Addendum No. 8

Reference: George S. Eccles Student Life Center
University of Utah – Salt Lake City, Utah
DFCM Project No. 08015750

Subject: **Addendum No. 8**

AD07-C1.0

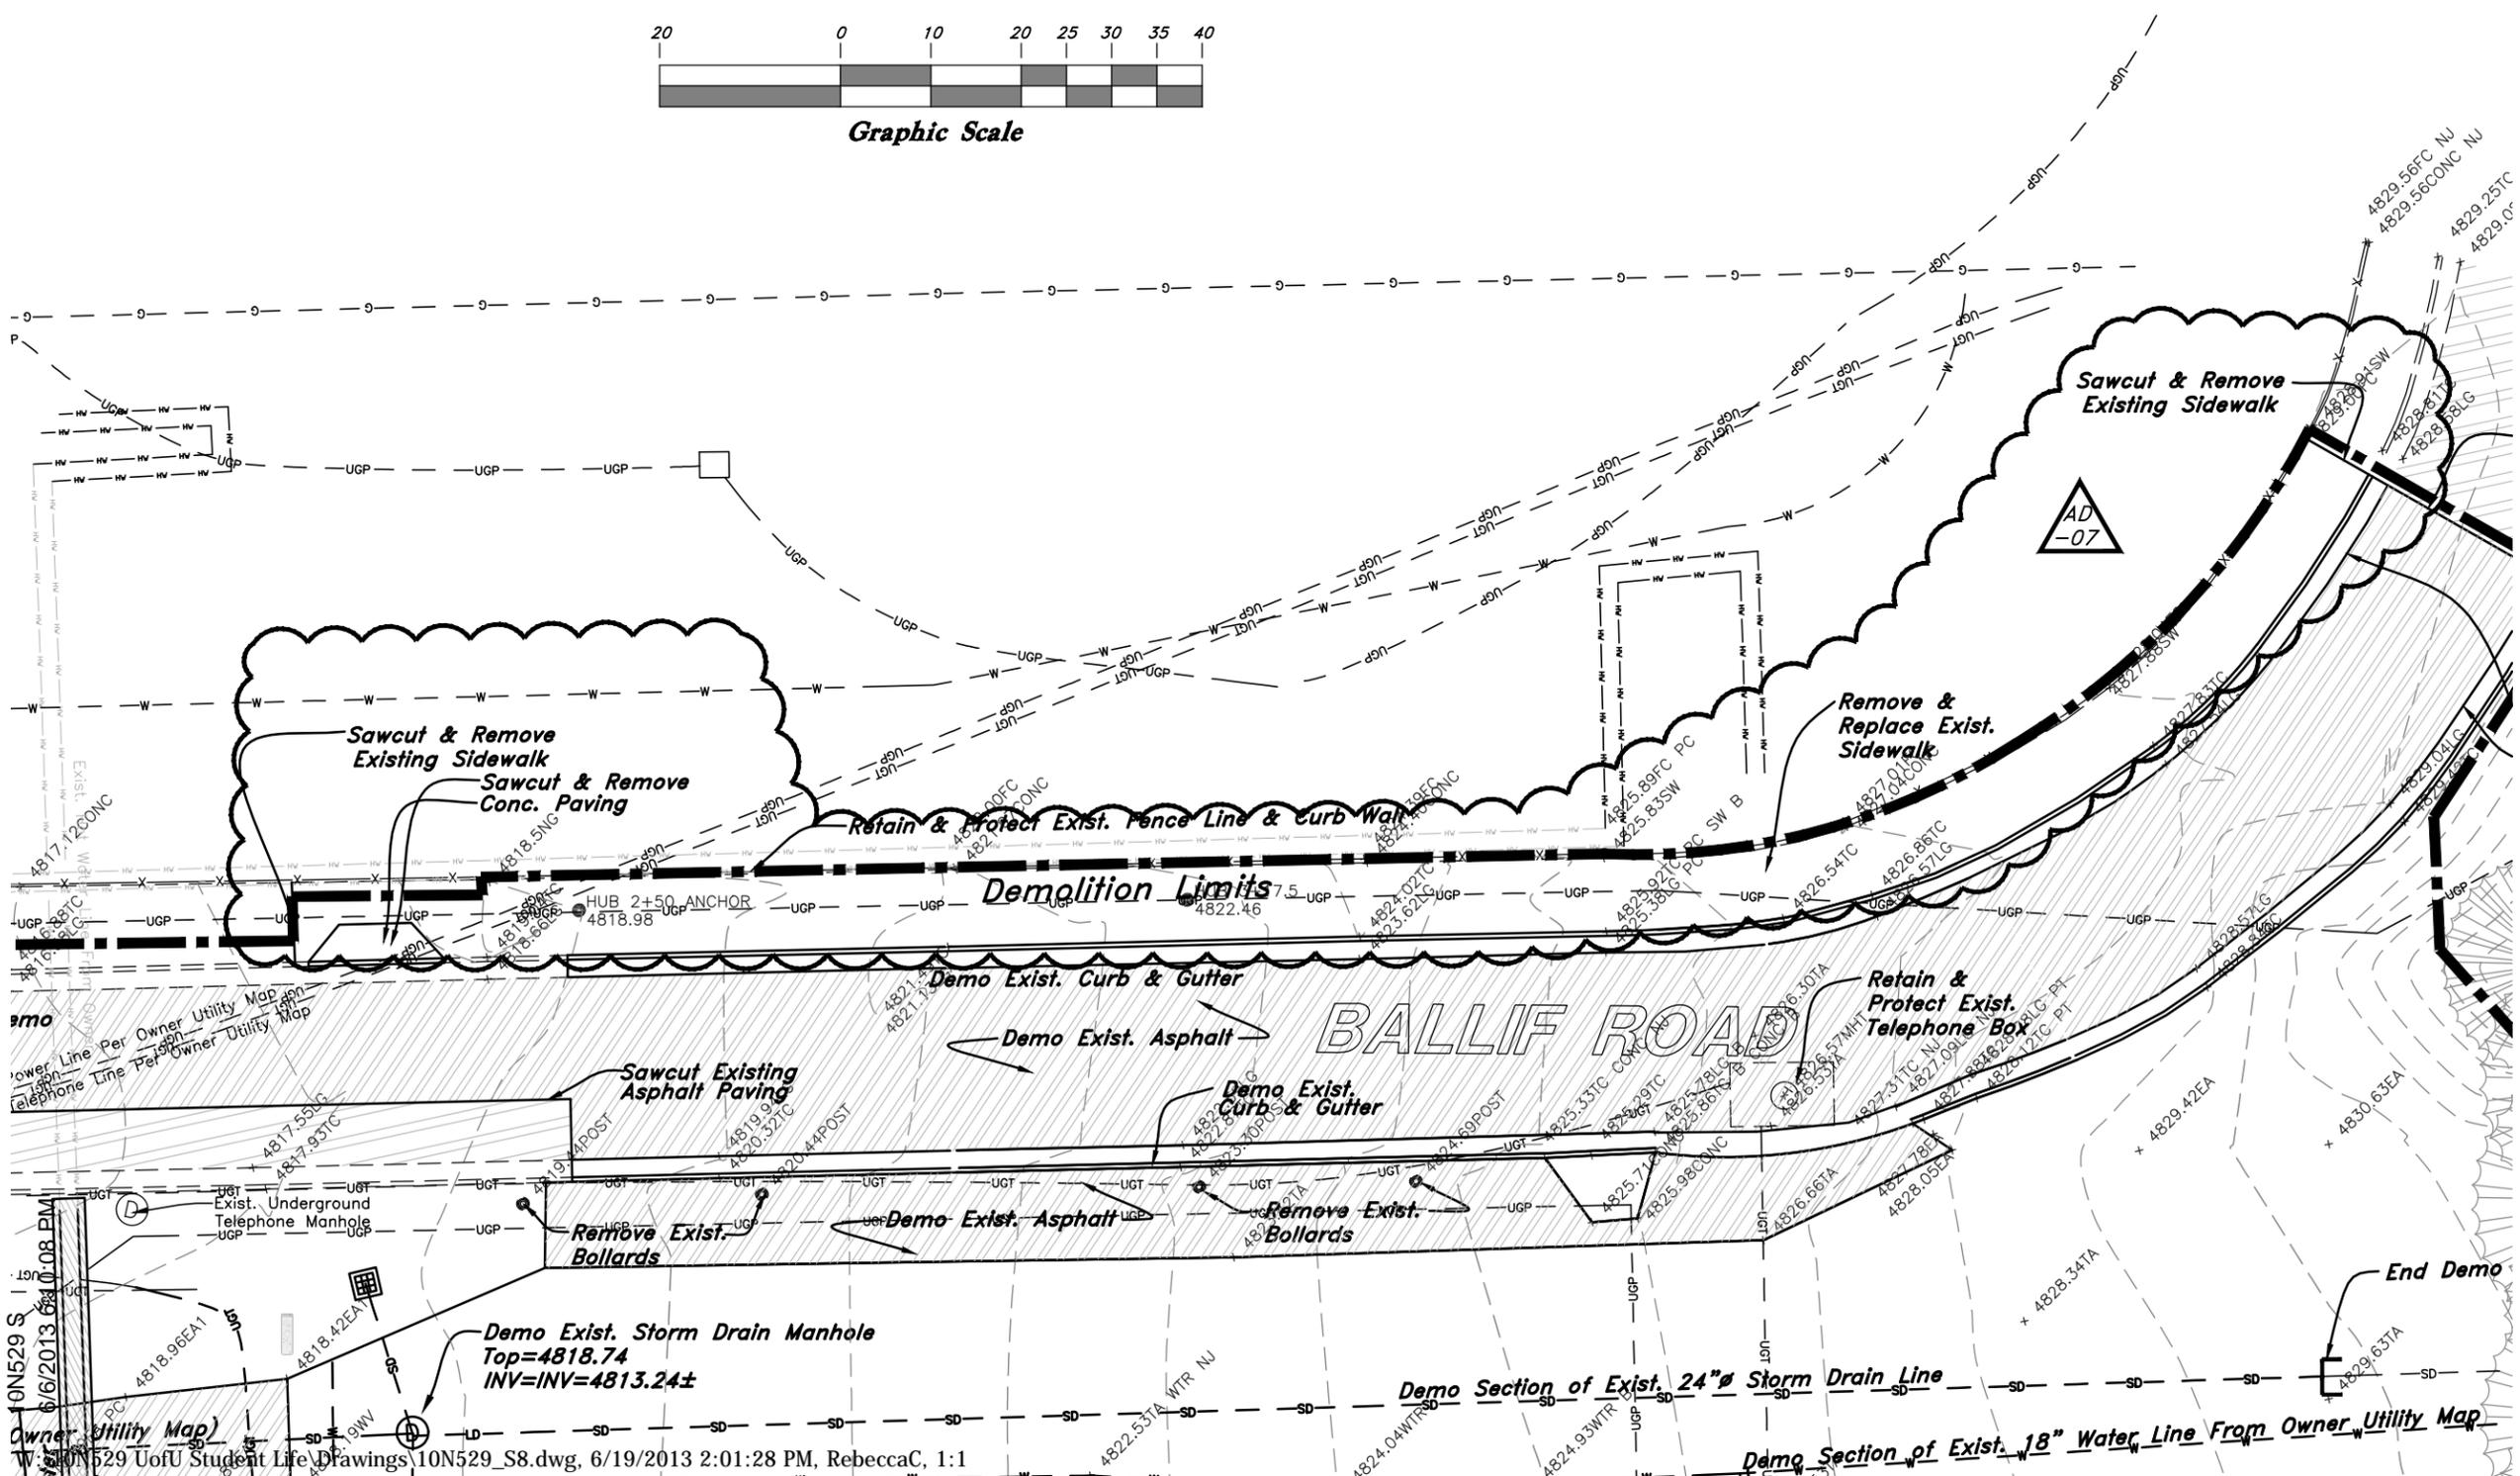
A7.13 Sheet CD002 - See attached sketch AD-7-C1.0 for revisions.

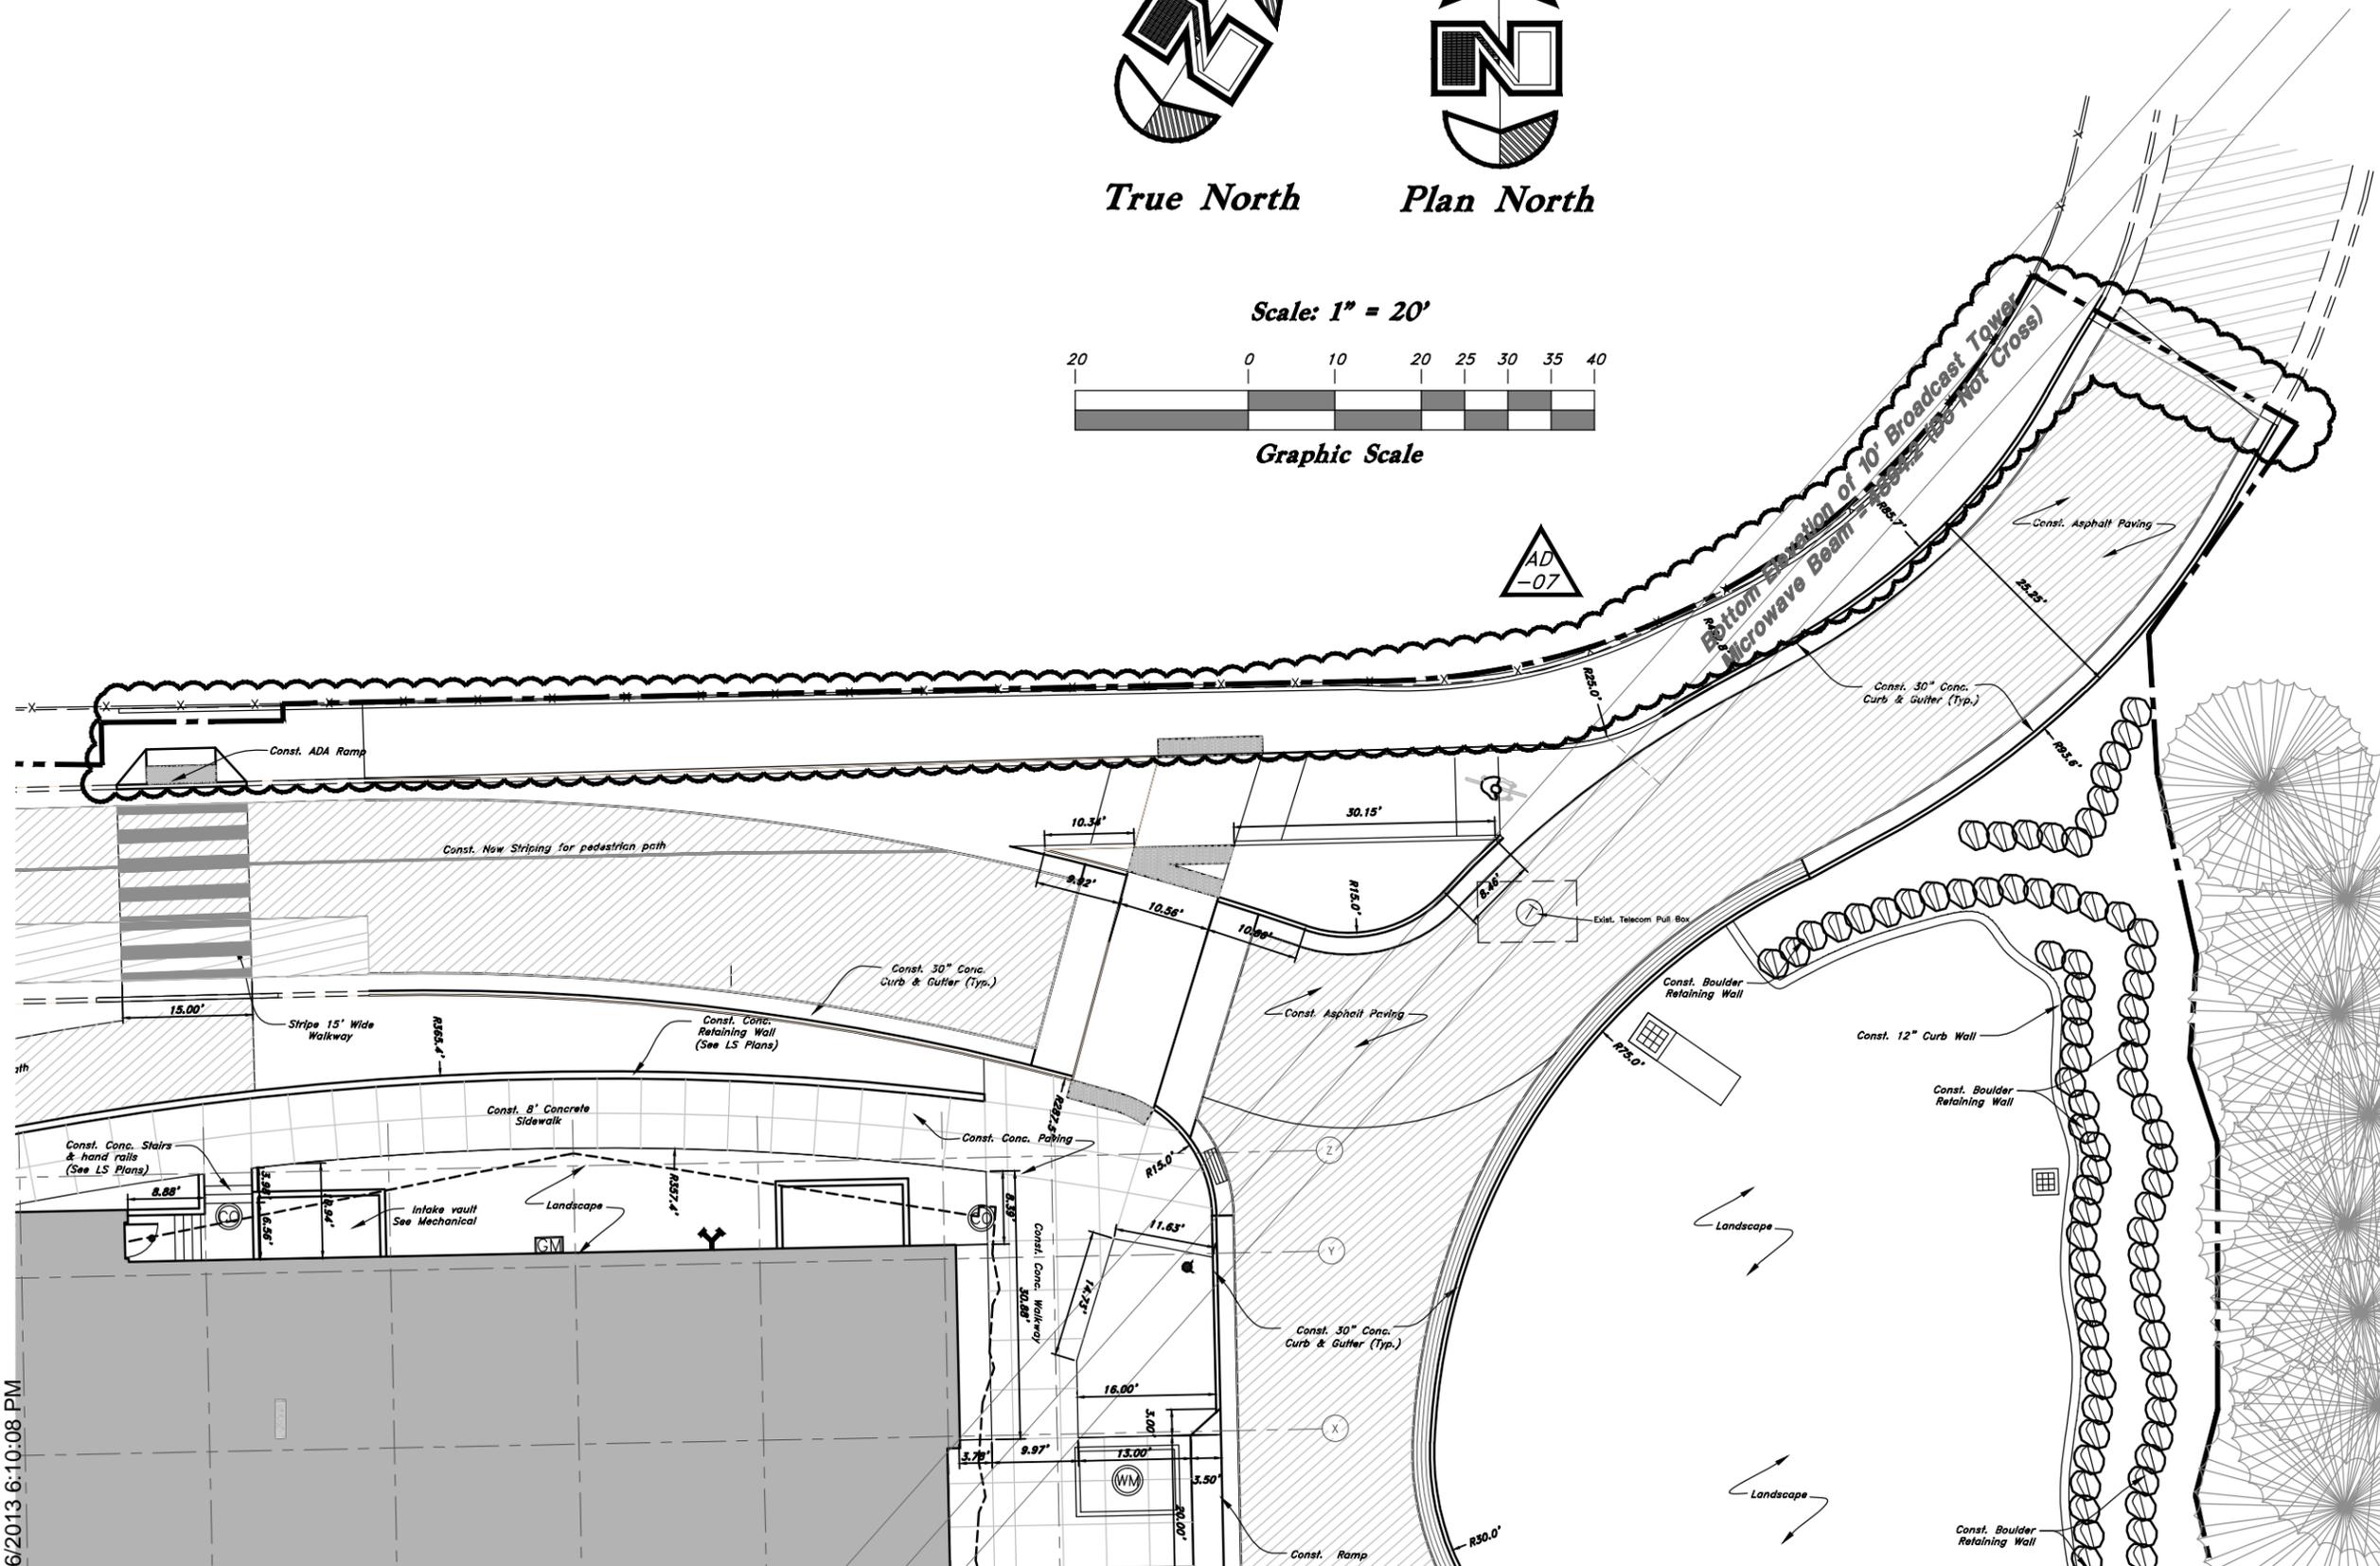
A7.14 Sheet CS102 - See attached sketch AD-7-C2.0 for revisions.

AD07-C3.0

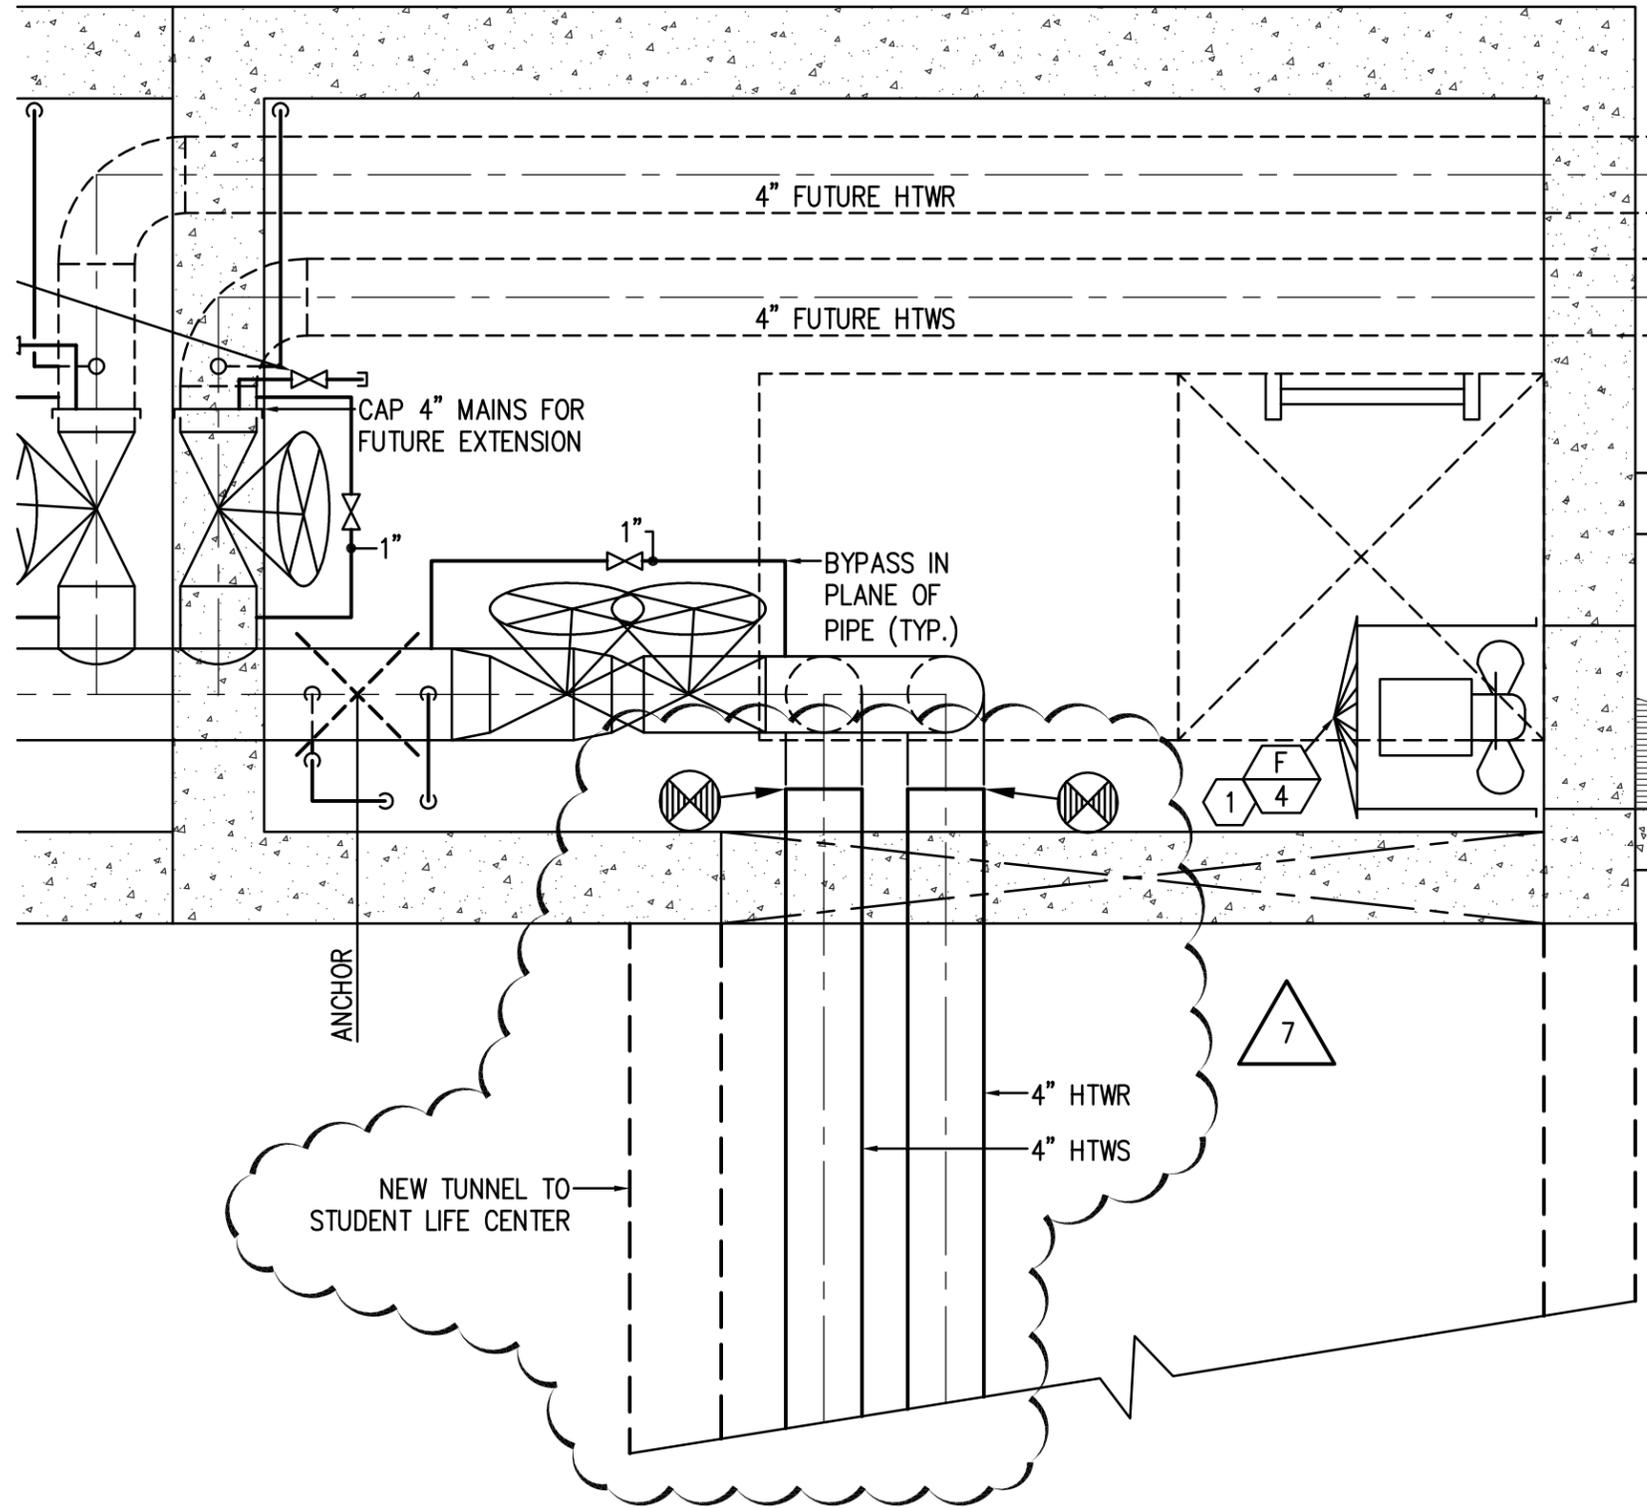
A7.15 Sheet CS403- See attached sketch AD-7-C3.0 for revisions.
